**LEXINGTON-FAYETTE URBAN COUNTY
GOVERNMENT CONTRACT CHANGE ORDER**

Date:	March 10, 2015
Project:	Senior Citizen Center Construction
Location:	Lexington
Contract No.	227-2014
Original Contract Amt.	\$8,882,900.00
Cumulative Amount of Previous Change Orders	\$180,584.31
Percent Change - Previous Change Orders	2.03%
Total Contract Amount Prior to this Change Order	\$9,063,484.31
Change Order No.	11

JUSTIFICATION FOR CHANGE

CHANGE ORDER: 11

Figure 1: Photo of Excavations

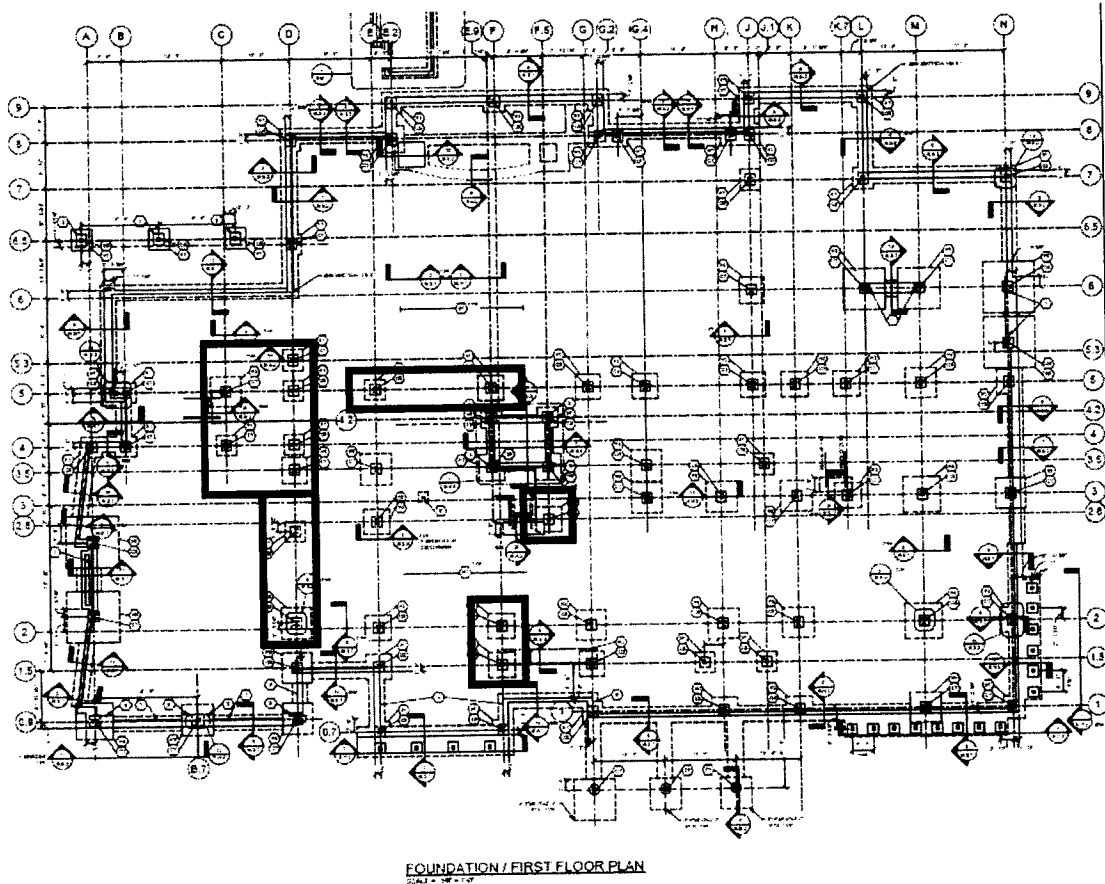
The writer observed the contractor excavate column footings at Column Lines C / 4 & 5, D / 2 – 5.3, E / 5, E.9 / 5, F / 1.5 & 2, and F.5 / 2.8. The footing excavations exposed tan to brown, saturated, soft, silty clay with topsoil. The exposed surface did not appear to be suitable for the design bearing capacity of 3,000 pounds per square foot. The writer observed the contractor undercut the areas to 24" below bearing elevation. The extra excavation exposed brown to dark brown, moist, soft, topsoil with organics. This surface appeared suitable for a bearing capacity of approximately 1,000 pounds per square foot, or less than the design bearing capacity. The areas were then undercut as follows:

Column Line	Undercut Depth (feet below bearing elevation)
C / 4	4
C / 5	6
D / 2.8	4
D / 2	5
D / 3.5	5
D / 4	4
D / 5	4

D / 5.3	4
E / 5	5
E.9 / 5	5
F / 1.5	5
F / 2	5
F.5 / 2.8	5

The undercut volume was calculated to be 54 cubic yards. The writer observed the contractor place 63 cubic yards of flowable fill in the excavations to bring them back to original bearing elevation.
